Louisiana Energy Services, L. P.
National Enrichment Facility
NRC Docket No. 70-3103

Subject: Response to NRC Request for Additional Information Regarding the National Enrichment Facility Environmental Report

**Louisiana Energy Services
Response to April 29, 2004,
Request for Additional Information**

Figure ER RAI 2-1
DATE: 5/20/04

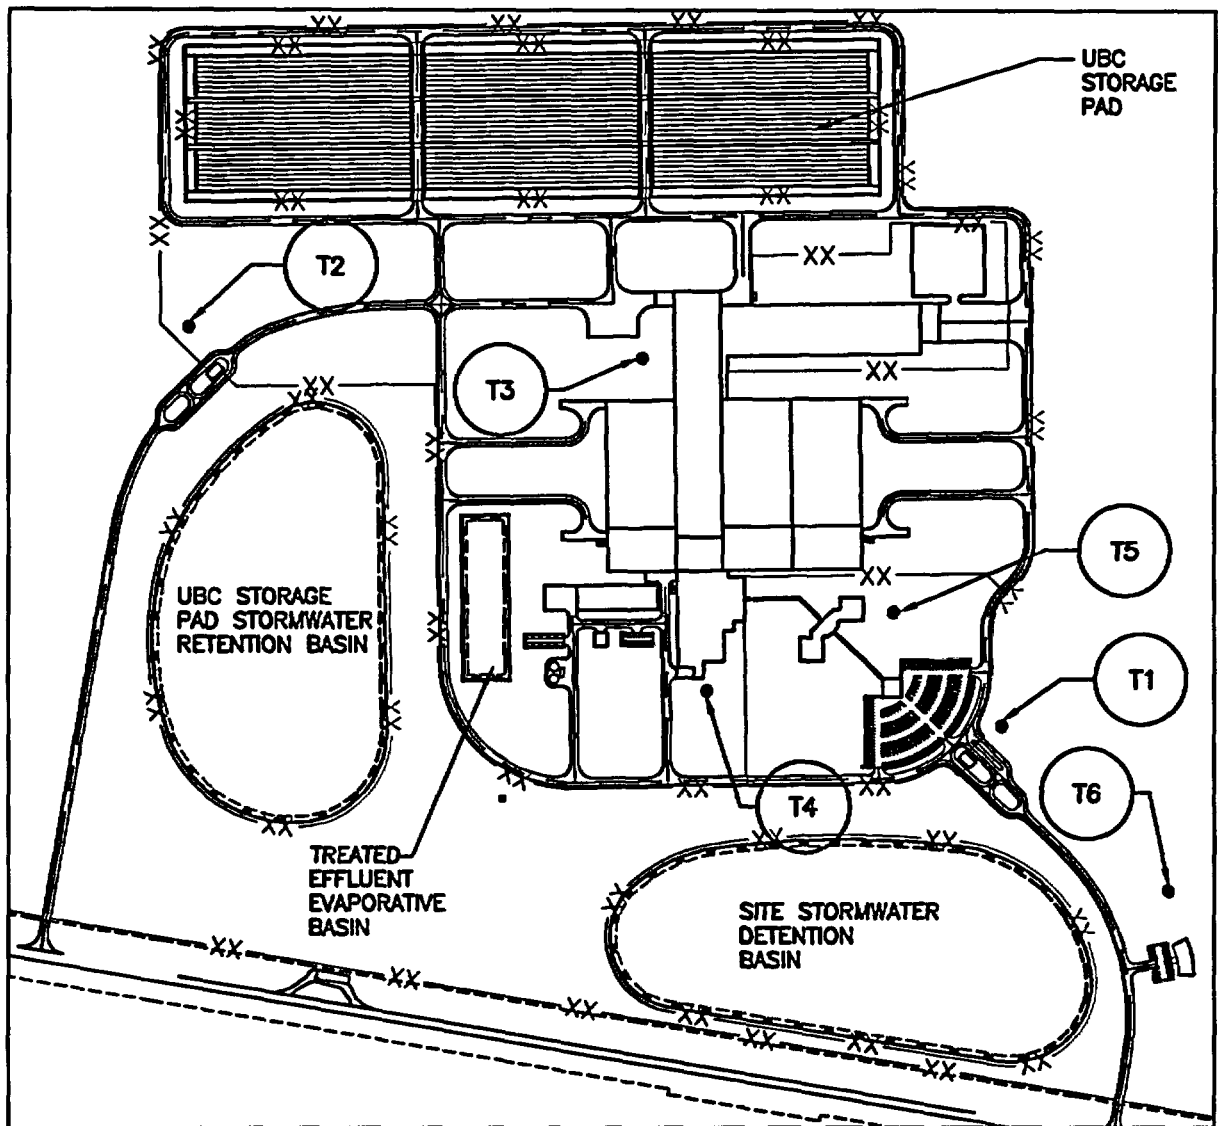
Provide a map or a figure to show the current CO₂ line location through the proposed NEF.

- Sections 2.1.2.1, 2.1.2.5, 4.1.1, and 4.1.2. state that the Trinity Pipeline, LLC, 10-in diameter, 2000 psi, underground CO₂ pipeline traverses southwest to northwest across the proposed NEF and would be re-routed but no maps show the current location of the pipeline.

FIGURE ER RAI 2-2

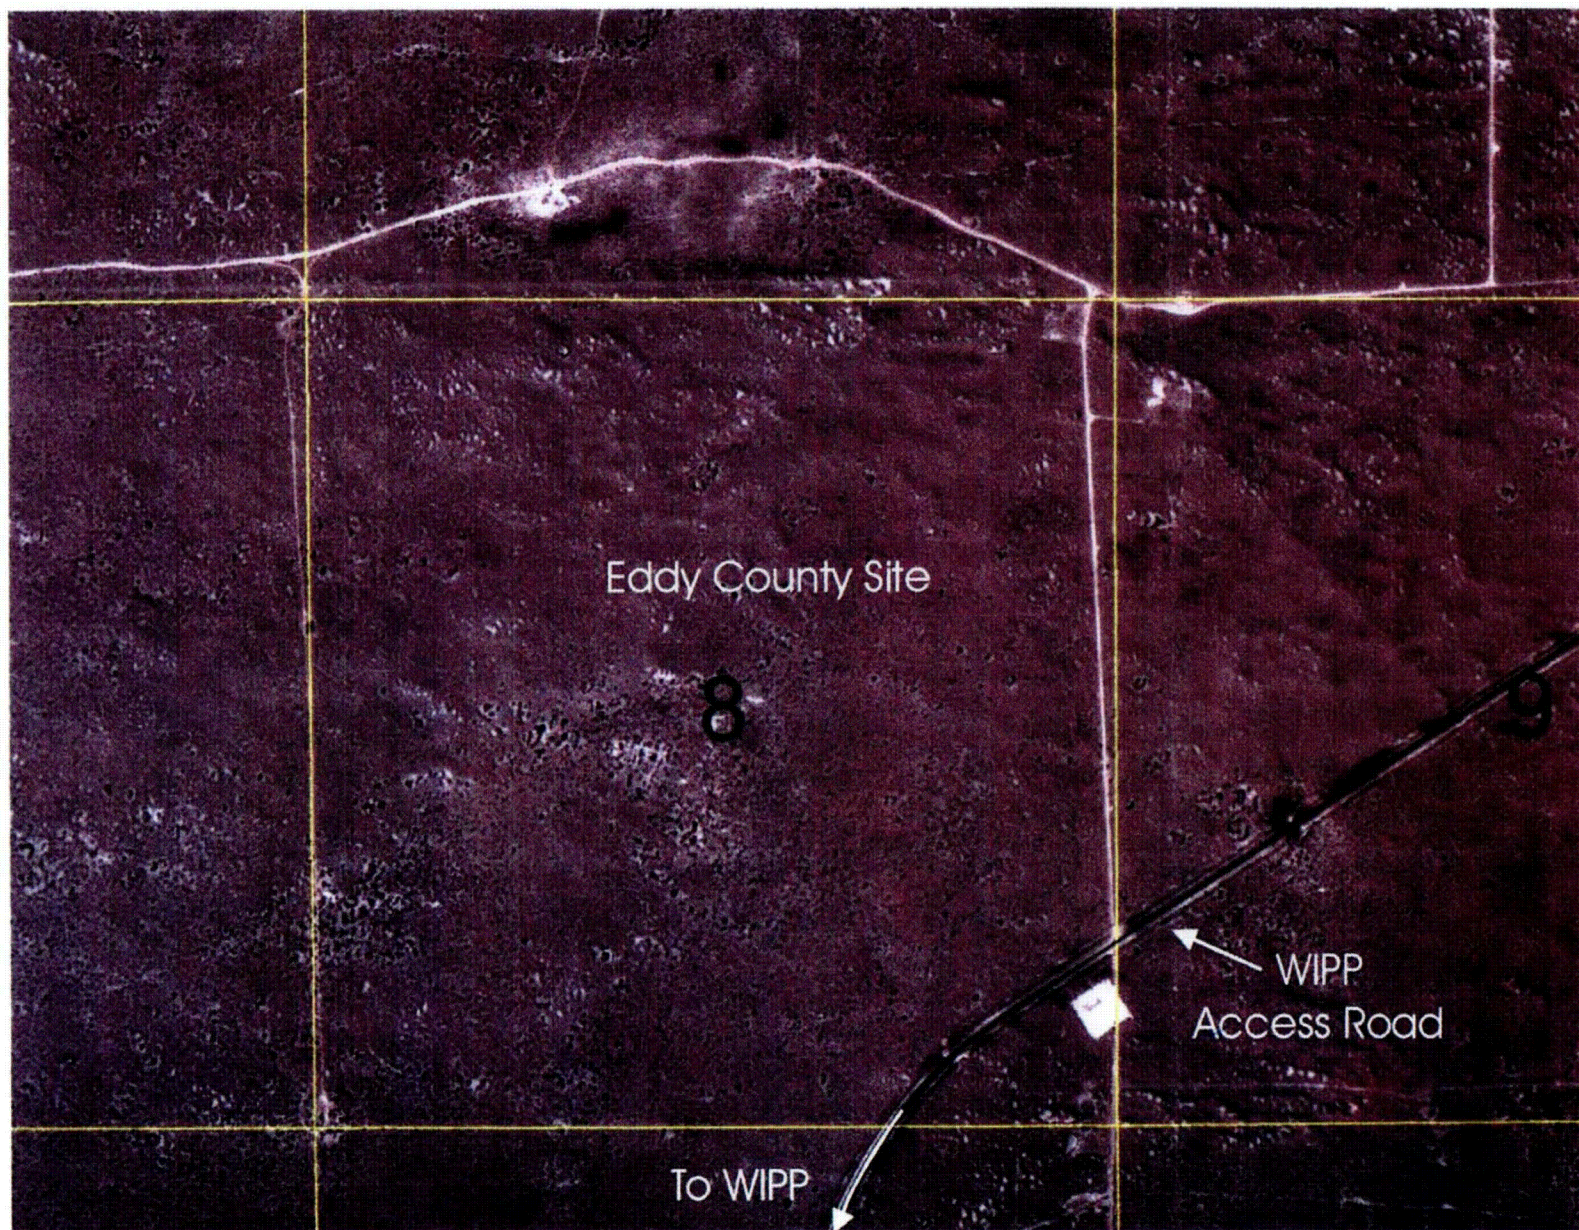
Provide a detailed description of the septic tanks and leach fields.

The design approach for disposal of sanitary wastes has been modified since the submittal of the ER. LES will incorporate a detailed description of the NEF septic systems in the next revision to the ER. Six septic systems are now planned in lieu of three septic tanks with a common leachfield. Each septic system will consist of a septic tank with one or more leachfields. Refer to Figure ER RAI 2-2, "Planned Septic Tank System Locations," in Attachment 3 to this submittal for the planned location of the six septic tank systems.

Figure ER RAI 2-7C.1

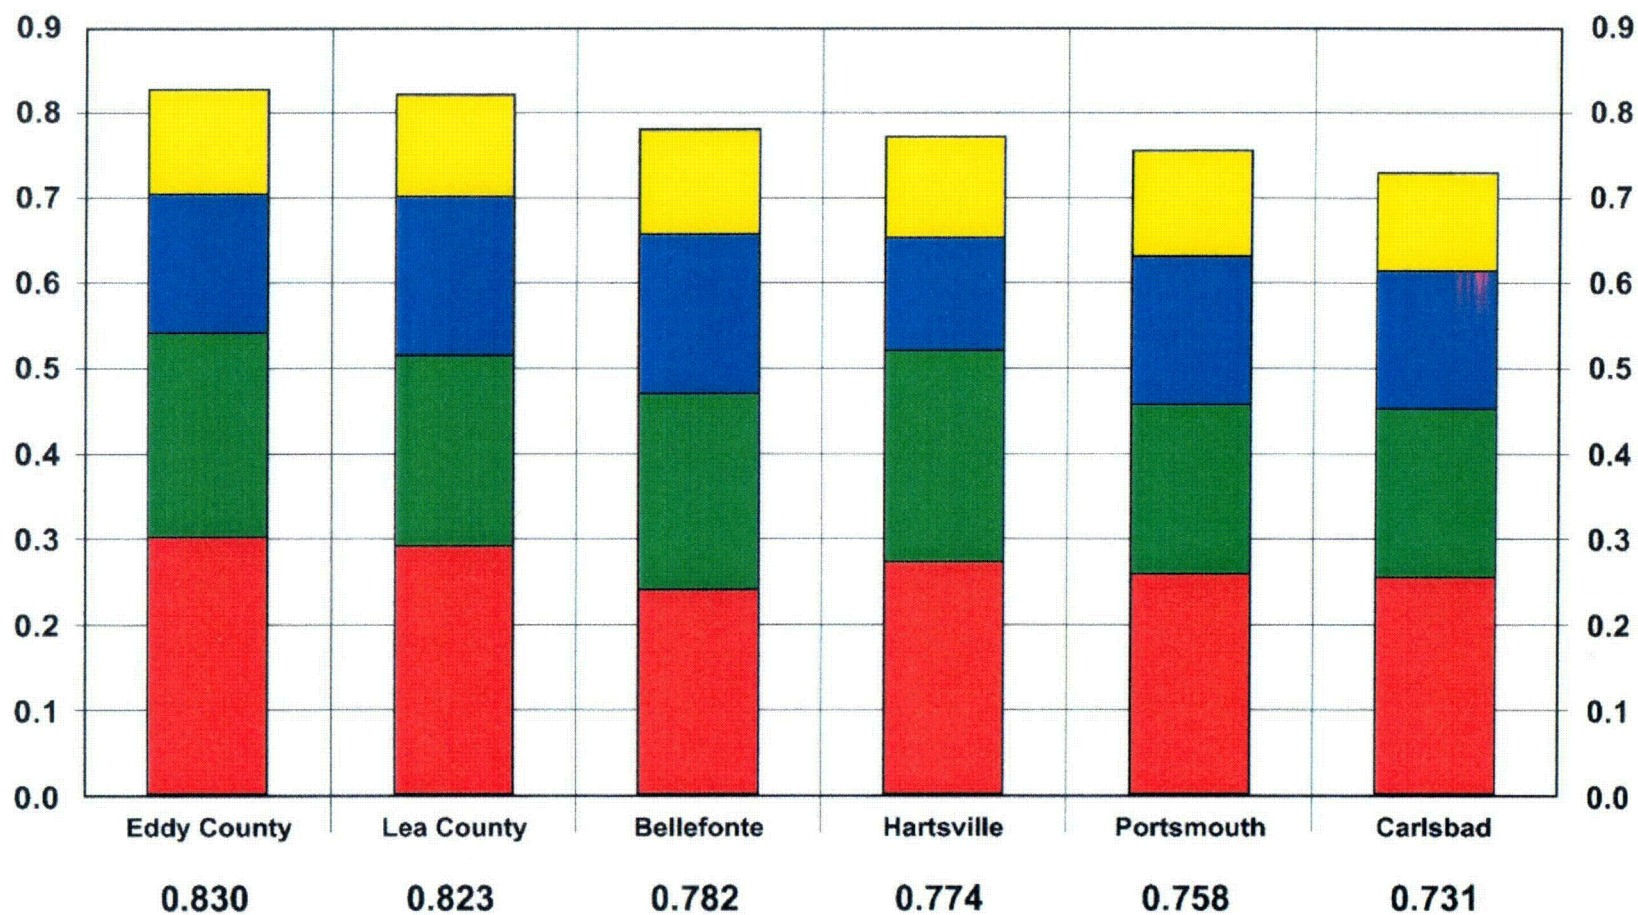
- C. Verify that the description of the Eddy County site is accurate in Section 2.1.3.3.4.2.
- The written description of the location of the Waste Isolation Pilot Plant (WIPP) access road and utilities indicate that the correct site is Section 11 of Township 22S, Range 31E of the New Mexico Meridian which is northeast of the current WIPP site. Section 2.1.3.3.4.2 identifies the Eddy County site as Section 8 of Township 22S, Range 31E of the New Mexico Meridian which is near the northwest corner of the WIPP site.

- C. The description of the Eddy County site in ER Section 2.1.3.3.4.2 is correct. Figure ER RAI 2-7C.1, "Aerial View of Eddy County Site," in Attachment 3 to this submittal provides an aerial view of the Eddy County site. As described in Section 2.1.3.3.4.2 and as shown on Figure ER RAI 2-7C.1, the main WIPP access road is on the southeastern edge of the site.

Figure ER RAI 2-7D.2

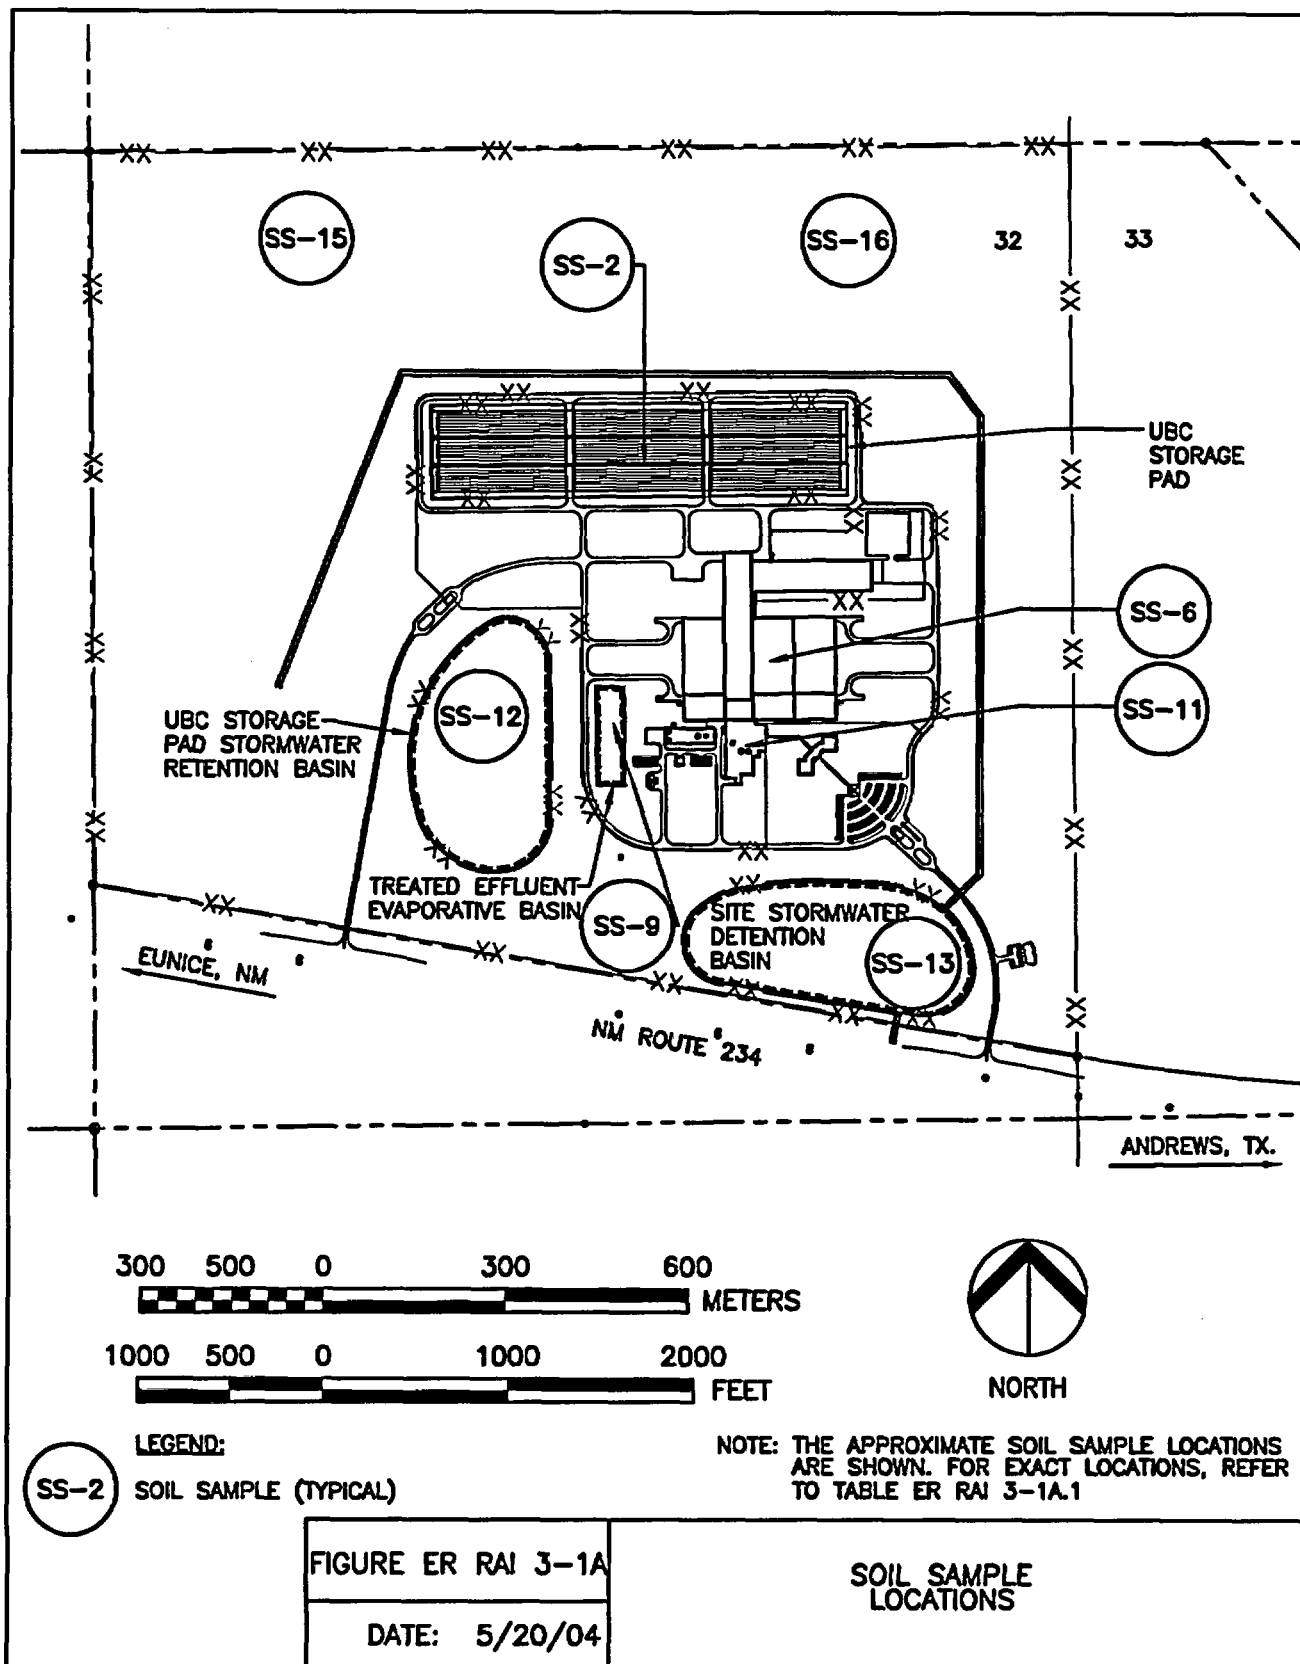
- A. Provide a sample calculation to allow the NRC to reproduce the site score results in Section 2.1.3.3.3.
- In Section 2.1.3.3.3, a summary is provided on how the site scores are calculated. Table 2.1-9 summarizes the unweighted scores of the sites against the second phase screening criteria. Figures 2.1-7 and 2.1-8 present the final weighted scores.

- D. Figures ER RAI 2-7D.1, "Contributions by Grouped Criteria," and ER RAI 2-7D.2, "Contributions by Criteria," in Attachment 3 to this submittal include the final weighted scores for the six sites, including Portsmouth. LES will revise ER Figures 2.1-7 and 2.1-8 to be consistent with Figures ER RAI 2-7D.1 and ER RAI 2-7D.2 in the next revision to the ER.

Figure ER RAI 4-1.2

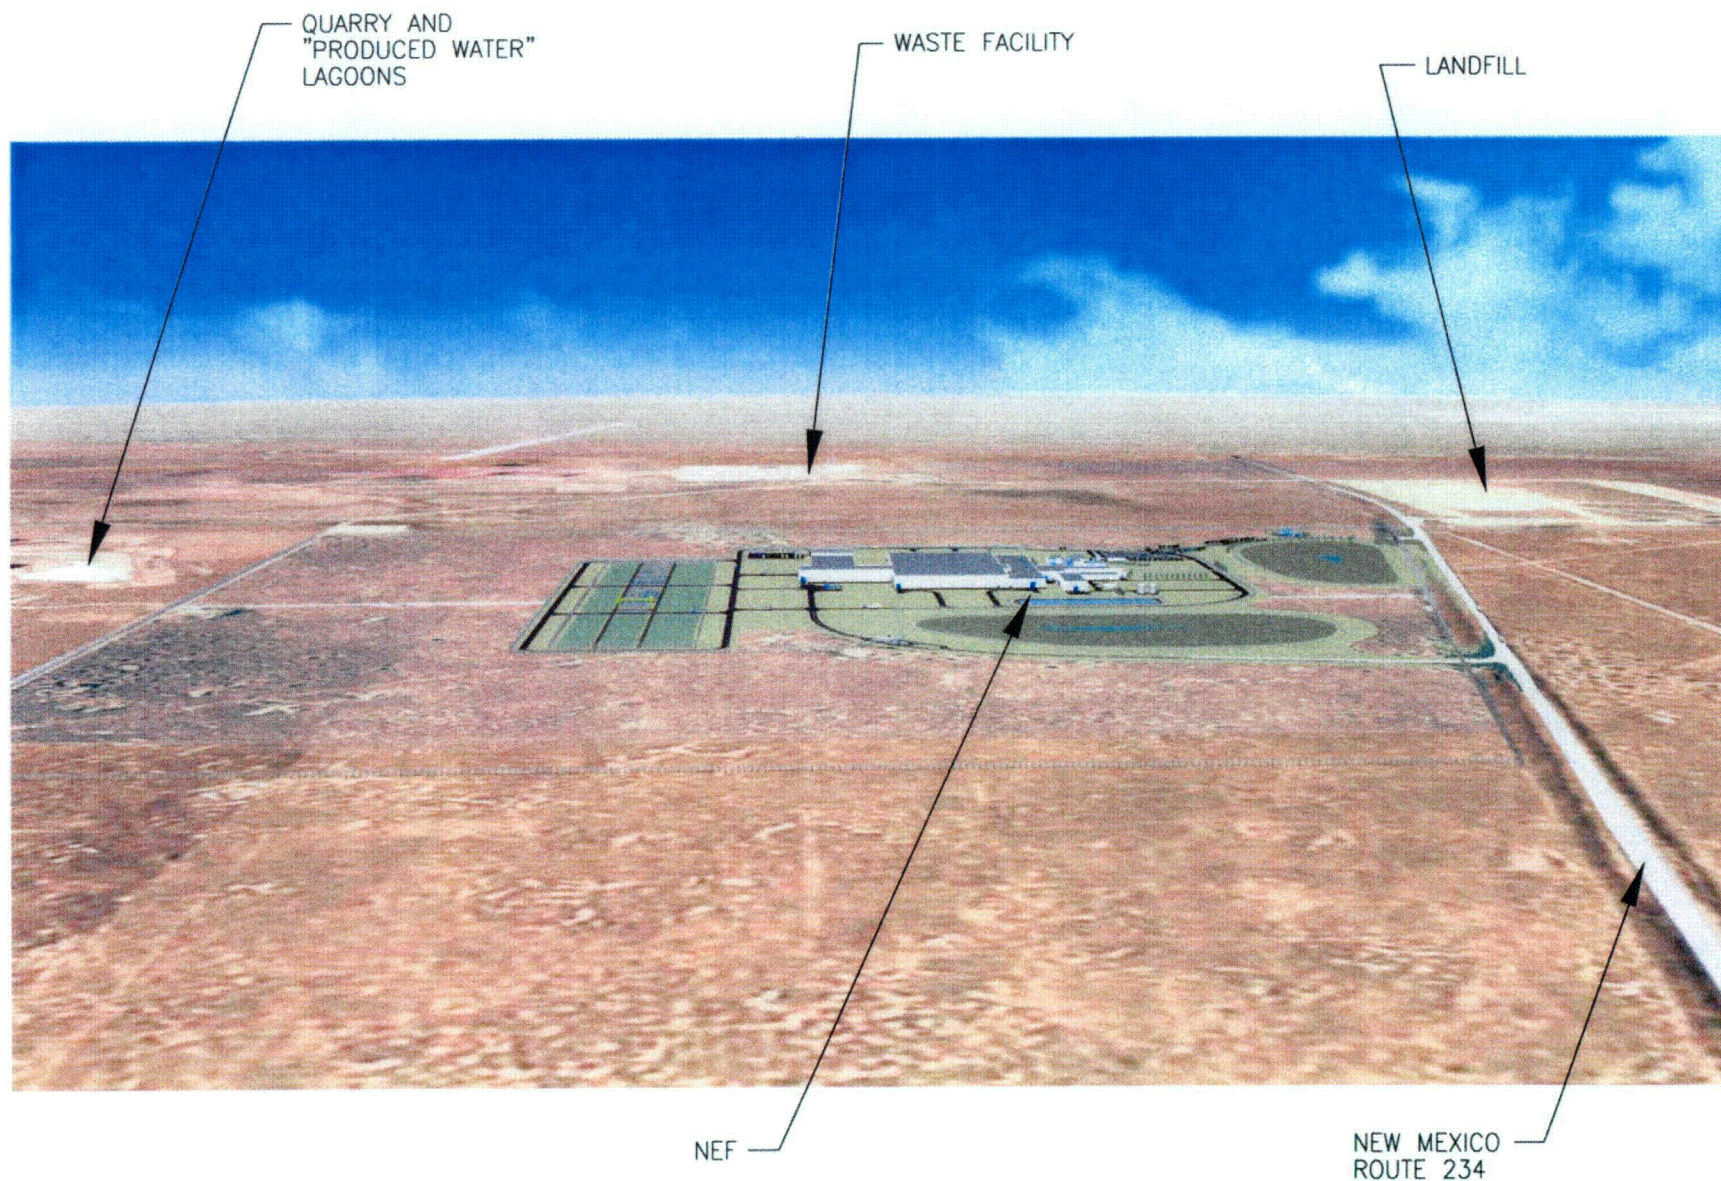
Provide a copy of the artistic rendering showing a view of the proposed NEF and how it would visually impact the site and surrounding area.

Figure ER RAI 4-1.1, "Aerial View," is an artistic aerial view of the NEF and surrounding area. Figure ER RAI 4-1.2, "View to the Northwest," Figure ER RAI 4-1.3, "View to the East," Figure ER RAI 4-1.4, "View to the South," and Figure ER RAI 4-1.5, "View to the West," in Attachment 3 to this submittal, provide artistic views of the NEF site and vicinity, looking to the northwest, east, south and west, respectively. The quarry and "produced water" lagoons to the north, the existing Waste Control Specialists (WCS) waste facility to the east, the county landfill to the southeast and New Mexico Route 234 to the south are shown in relation to the NEF site. Land to the west, occupied by a petroleum contaminated soil treatment facility, is undeveloped. Viewing the surrounding area from the NEF site, and looking northward, the quarry and "produced water" lagoons are at a higher elevation. To the east, several low-rise buildings associated with the WCS waste facility are apparent at a distance. Earthen mounds are apparent to the southeast, across New Mexico Route 234. No structures are visible on the adjacent property to the west.
